CPED STAFF REPORT

Prepared for the City Planning Commission
 CPC Agenda Item #12
 November 13, 2018
 PLAN7701

Property Location: 2645 1st Avenue, 2637 1st Avenue
Project Name: 2645
Prepared By: Peter Crandall, Senior City Planner, (612) 673-2247
Applicant: Daniel Oberpriller, North Bay Companies
Project Contact: Scott Nelson, DJR Architecture, Inc
Request: To construct a new 5 story residential building with 51 dwelling units.
Required Applications:

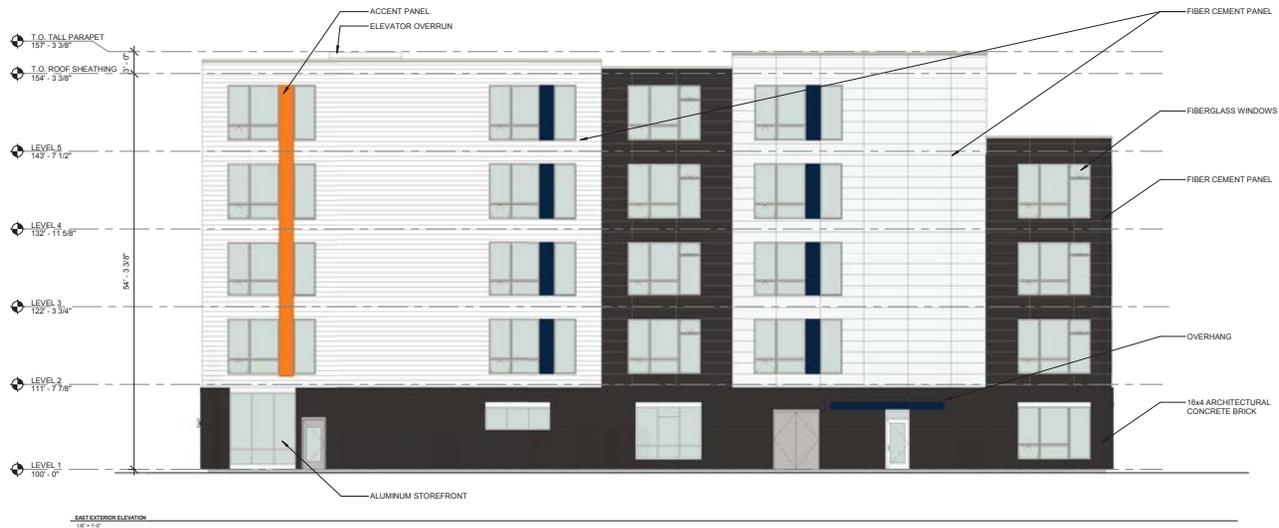
- **Windows.** The first floor of the elevation facing an onsite surface parking lot contains less than the required 20% window area. The proposal contains 19% windows. Staff finds that the proposed window area would meet the intent of the ordinance and would be sufficient for providing safety and surveillance for the on site parking lot and is recommending that the Planning Commission grant alternative compliance for this requirement.
